**REFERENCE: DIPLOMAT HOUSE A/K/A DIPLOMAT NORTH RPD
DCI2023-00050
1st Sufficiency Response**

This letter is written in response to the review comments dated January 18, 2024.

Diplomat House f/k/a North Diplomat RPD Amendment

DCI2023-00050 – Revised March 2024

DATE	PROJECT	DRAWING	DESIGN	CHECKED	SCALE	SHEET	OF	FILE NO. (S-R)
08-27-2007	2028	MCP			1"=100'	2	3	34-43-24

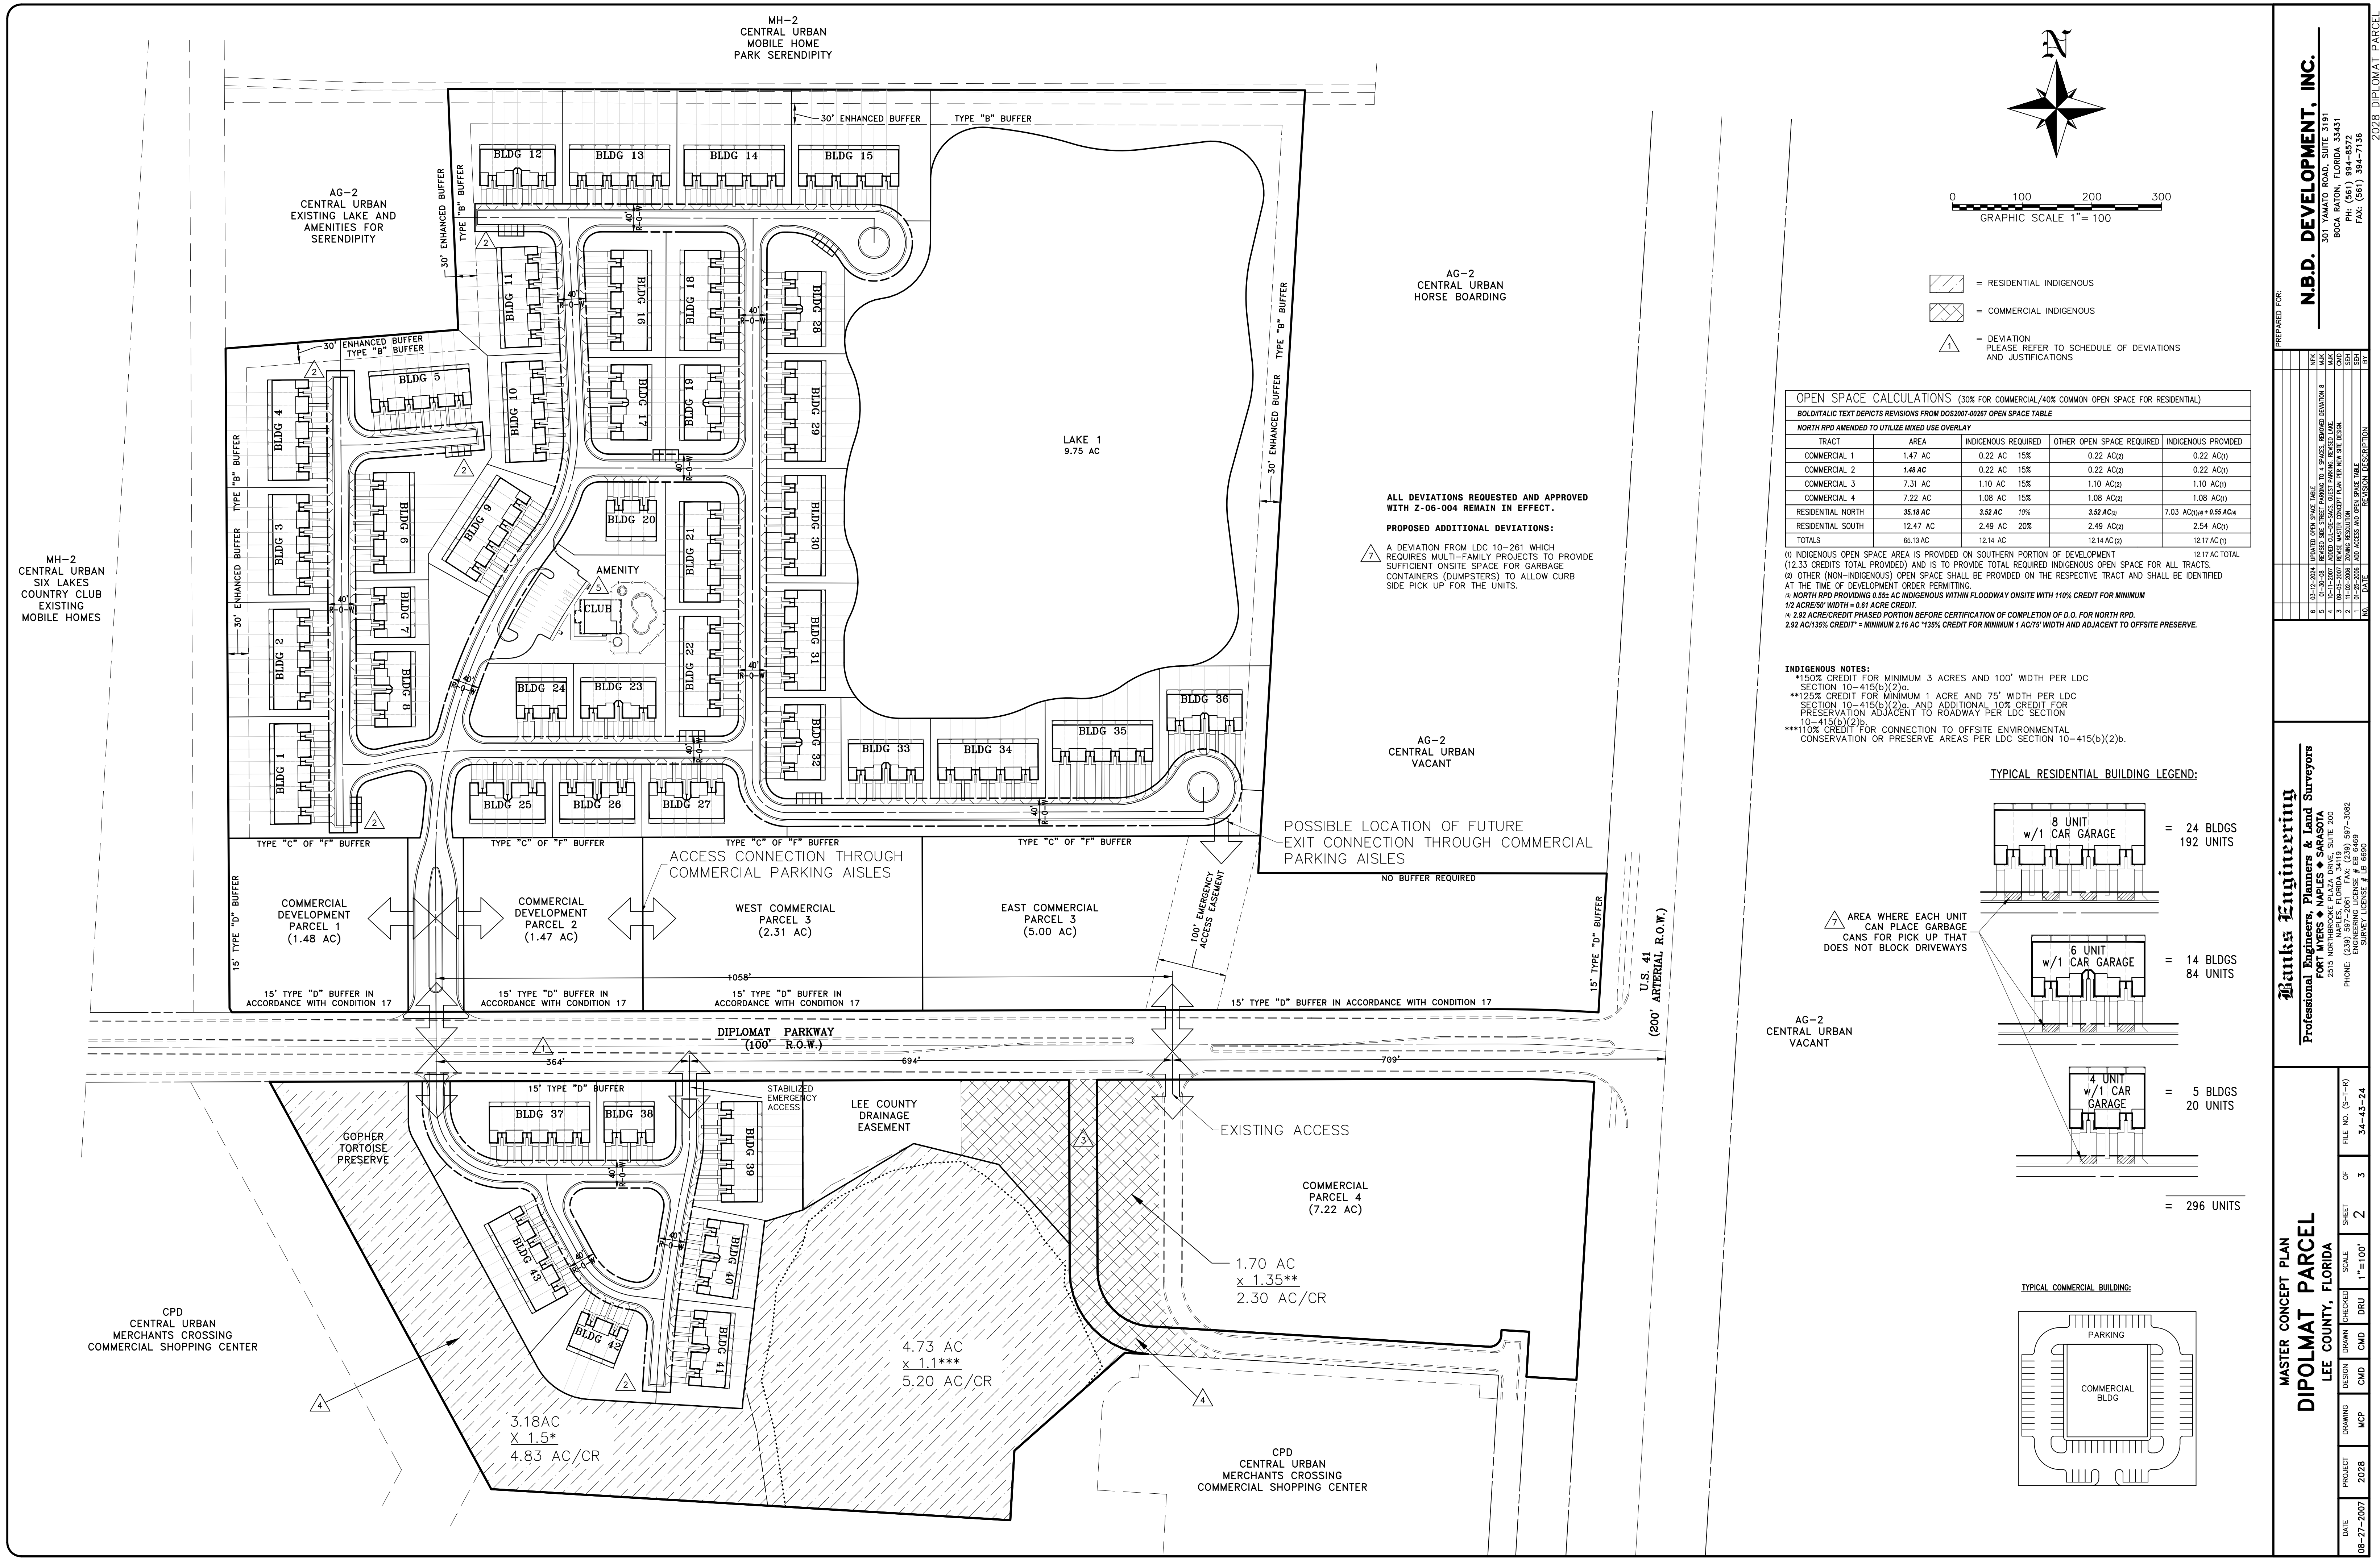
Comment 5: With the amendment to Condition 22 (Open Space), the open space calculation on the Original Master Concept Plan Sheet will need to be amended.

Comment 9: Please confirm that both proposed gates meet the requirements of LDC Section 34-1748.

Response: Please see attached revised MCP and revised Condition 14. Condition 22 is now proposed to be deleted.

Response: Please see attached revised MCP and conceptual gate exhibits.
